Turin, 11th November 2010

CAMPAIGN – Service Campaign
Fiat Punto EVO models, with 1.4 105 HP MultiAir engine
- tappet cover

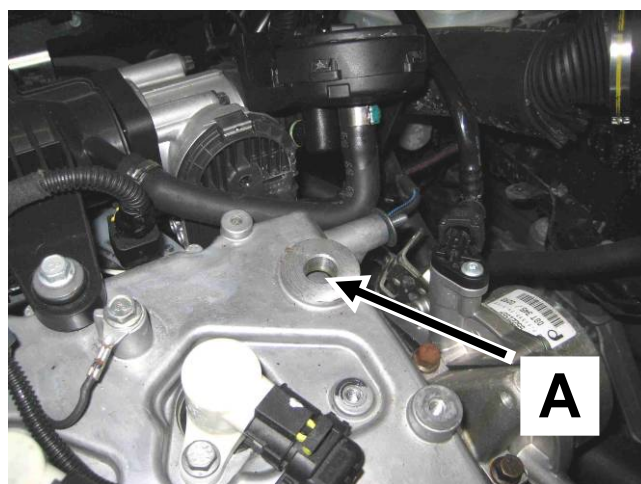
- Locate the hole (A) on the tappet cover, as shown.

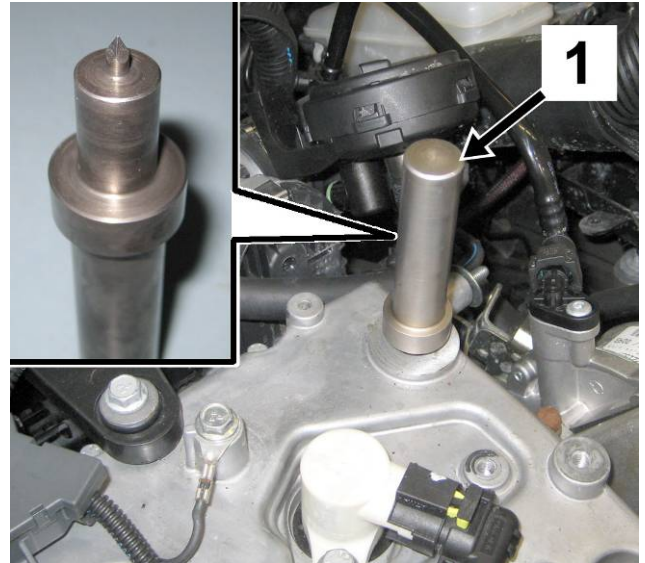
- Fit the sheet panel drilling tool (1) in place as shown.
- Keep the tool aligned with the tappet cover, without wide angles.
- Using a 500-g hammer, suitably hit the drilling tool, so that it goes through the tappet cover sheet panel.
